FINAL ENVIRONMENTAL IMPACT STATEMENT USDA-SCS-ES-WS-(ADM)-74-12-(F)

SAN FELIPE CREEK WATERSHED PROJECT

Val Verde County, Texas

Discussion and Disposition of Each Comment on Draft Statement

SECTION OF A TYPICAL FLOODWATER RETARDING STRUCTURE Figure 1

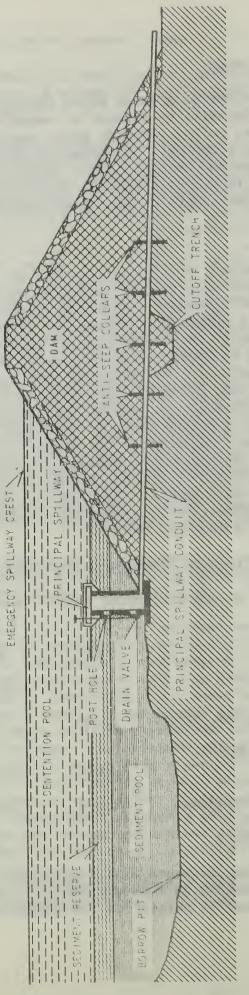
The Department noted that elevations shown on Figure 2A of the Work Plan do not correspond with the sea level elevations shown in the ENVIRONMENTAL SETTING section of the Draft Environmental Impact Statement; hence, the principal and emergency spillway crest elevations are not clear.

The Department stated that Figure 2A of the Work Plan indicates a borrow source is to be located downstream from the dam. The Plan of Highway Development for Del Rio published in 1965 proposes the development of a highway connection between U. S. 90-East and U. S. 90-North extending across San Felipe Creek through the area south of the proposed dam near the indicated borrow source. It is very possible that the location of the borrow area will conflict with the proposed highway location. It is recommended that before project implementation, possible conflict be resolved with the Texas Highway Department district engineer in Del Rio.

Elevations shown on Figure 2A of the Work Plan are typical for a floodwater retarding structure. The elevations are not the elevations for the San Felipe Creek site. Sea level elevations shown on Page 2, ENVIRONMENTAL SETTING, of the Draft Environmental Impact Statement, are the range of sea level elevations for this watershed.

Figure 2A is for a typical floodwater retarding structure and not the San Felipe Creek site. No borrow will be obtained from below the site. The proposed highway connection between U. S. 90-East and U. S. 90-North extending across San Felipe Creek will not interfere with the proposed site.
